POWER PLANT - NACELLE - POWERPLANT - REPLACEMENT OF FCD LATCH HOUSING FASTENERS -
CATEGORY CODE 7 - MOD.NAC-71-0170

V2500-NAC-71-0170

REMOVAL/INSTALLATION OF LATCH HOUSING FASTENERS
FIG.1

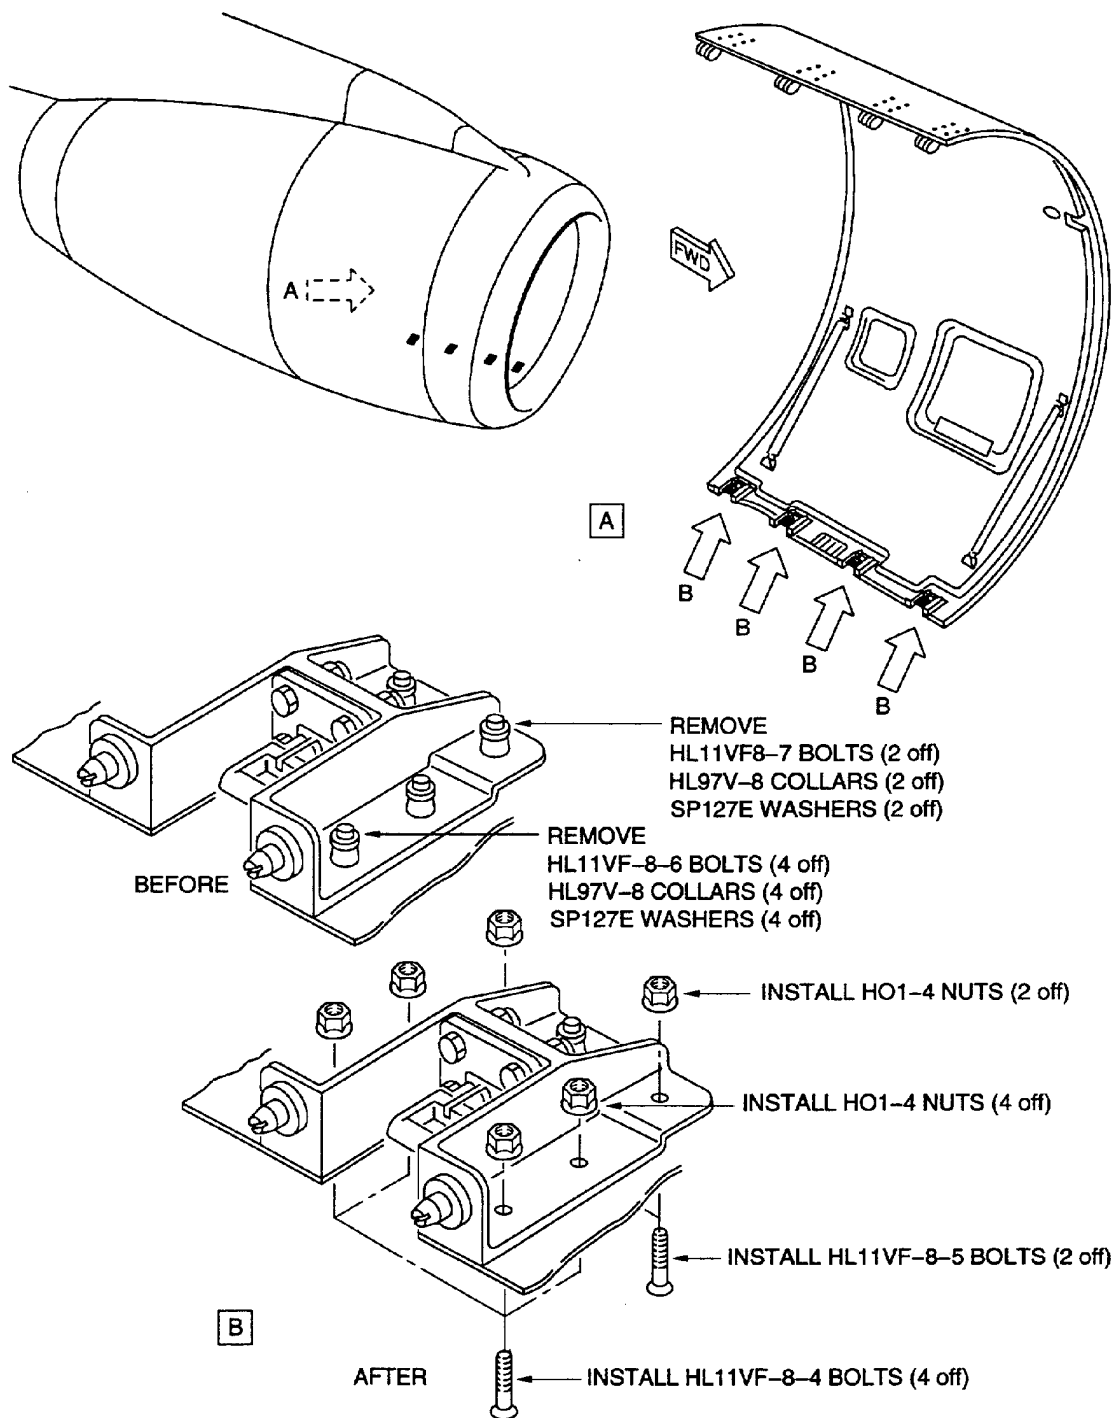
Minimum clearance has been observed between the fasteners on the left Fan Cowl Door latch assemblies and the Fan Cowl Door locating pins when the door is in the closed position.

- (a) The existing nuts and bolts are removed and replaced with new shorter bolts and low profile nuts.

- (1) Remove two HL11VF8-7 bolts, two SP127E washers and two HL97V-8 collars, as shown, from the left Fan Cowl Door latch housing (Refer to Figure 1)
- (2) Install two HL11VF8-5 bolts and two H01-4 nuts to the left Fan Cowl Door latch housing as shown.
- (3) Remove four HL11VF8-6 bolts, four and four HL97V-8 collars from the left Fan Cowl Door latch housing
- (4) Install four HL11VF8-4 bolts and four H01-4 nuts to the left Fan Cowl Door latch housing as shown.
- (5) Torque the six H01-4 nuts to 100 lbfin (11.3 Nm)
- (6) Do steps 2.B.(1) thru 2.B.(5) at the three remaining latch housing positions.
- (7) Restore the exterior paint finish on the left Fan Cowl Door.
